IREDELL COUNTY HEALTH DEPARTMENT

IMPROVEMENT PERMIT / AUTHORIZATION TO CONSTRUCT / OPERATION PERMIT / EXISTING SYSTEM INSPECTION

PERMIT# 144232 PIN# 4659052799 M. Lamache DATE 8-22-07

SUBDIVISION Windward Pt. BLOCK / SECTION 3 LOT 177 LOT AREA .92Acre SITE CLASS. PS DESIGN FLOW 360gpd T.A.R. .3

INITIAL SITE SKETCH

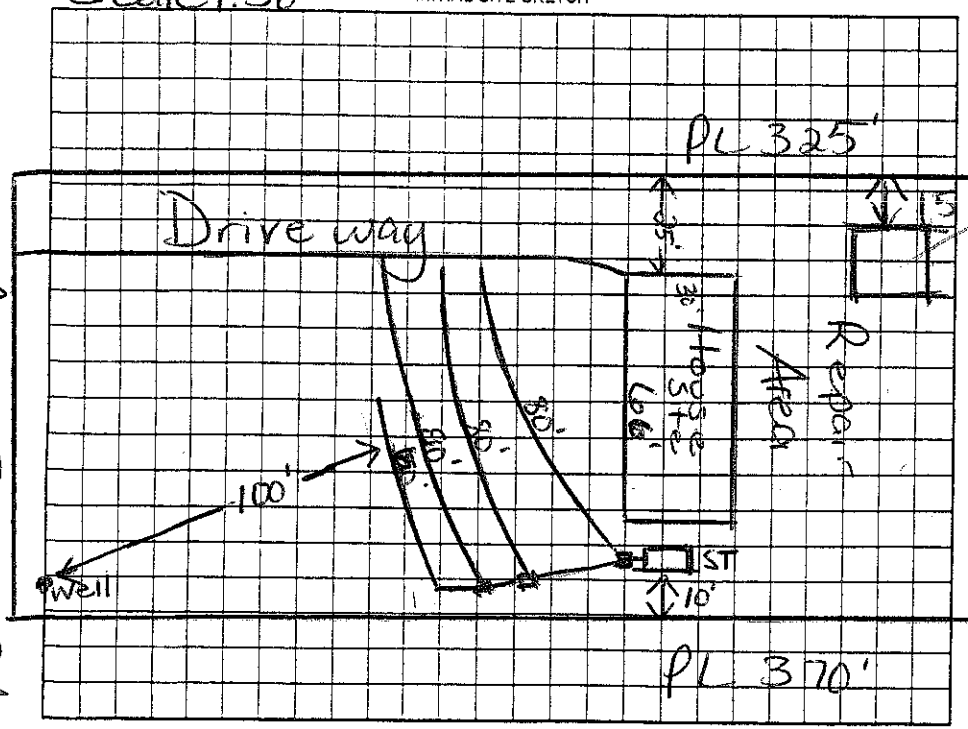
Comments/Conditions: Drainfield is in Saprolite, must maintain 100Ft setback to well.

AS BUILT SKETCH

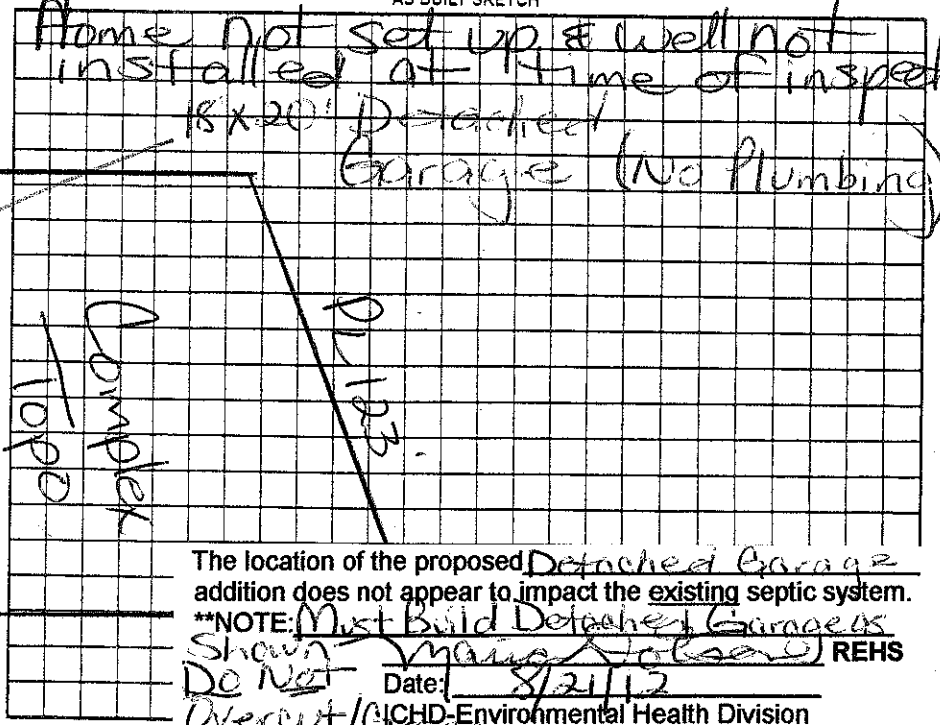
The location of the proposed Detached Garage addition does not appear to impact the existing septic system.

**NOTE: Must Build Detached Garages as Shown Do Not Overcut Grade
